Submission to NEPM air quality review regarding cost benefit analysis

Submission to NEPM

August 2019

Figure 2: Aurecon sensitivity of results to changes in technical assumptions

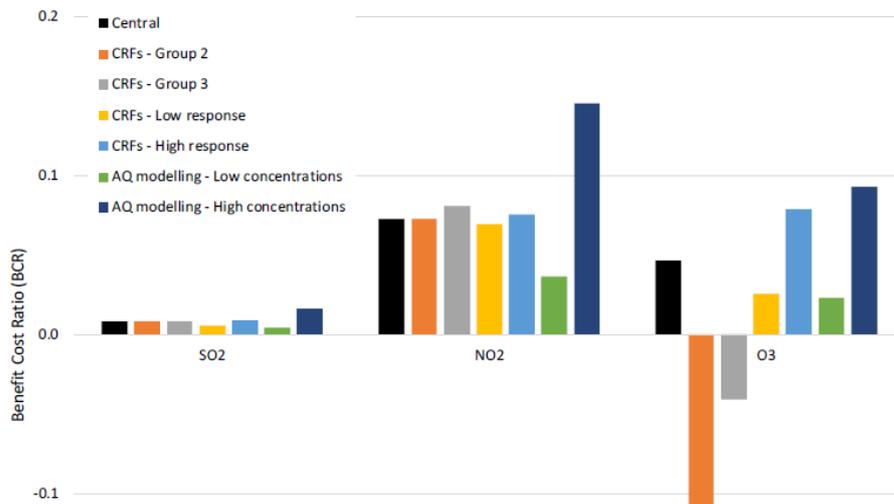
Figure 2 shows that Aurecon’s estimates for the value of changes to SO2 pollution barely change from the extremely low ratio of 0.01, while NO2 estimates show a similar trend around 0.07. Most unusual of all is the finding that benefit-cost ratios for reducing ozone pollution could be negative. Negative cost benefit ratios suggest that benefits are negative, while costs are substantial. This suggests that under some of Aurecon’s assumptions introducing ozone pollution control measures would make health outcomes worse.

Figure 7: FGD installation costs (USD per kW)

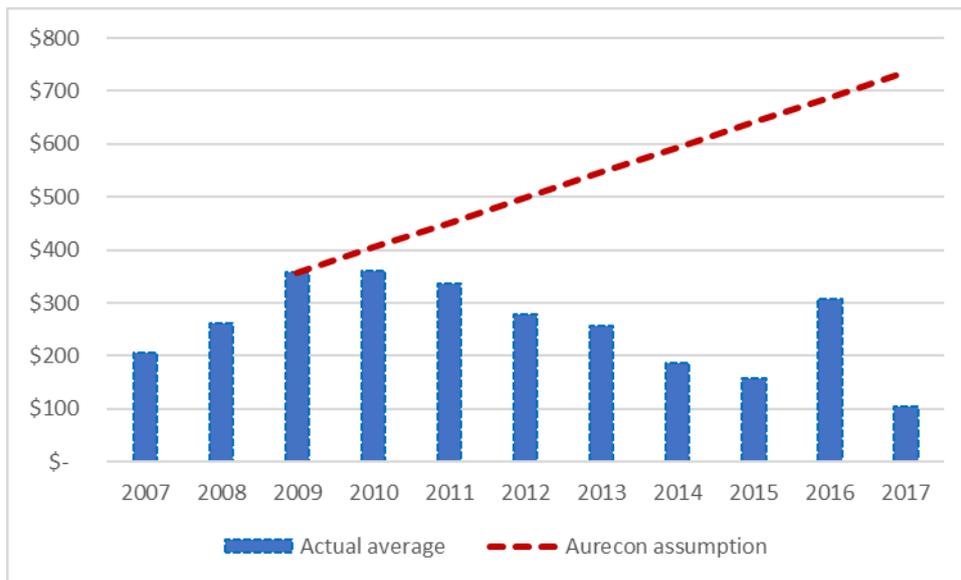
It is unclear exactly how Aurecon estimated its cost of AUD 1,090 per kW. Aurecon quotes two source for its cost calculations. One source is Cichanowicz (2010),³⁷ which reported FGD costs rising from \$342 per kW between 2004-07 to \$407 per kW in 2010 and included some forecasts out to 2015. Cichanowicz does not forecast costs to 2019 or further into the future and does not provide a specific figure that supports Aurecon’s \$1,090 figure. Instead, it appears Aurecon uses Cichanowicz’s prediction of further FGD cost increases to extrapolate rising FGD costs to 2019. The problem is that these increases never happened. The US cost of FGD installation has fallen every year since 2009, except 2016, as shown in Figure 7.
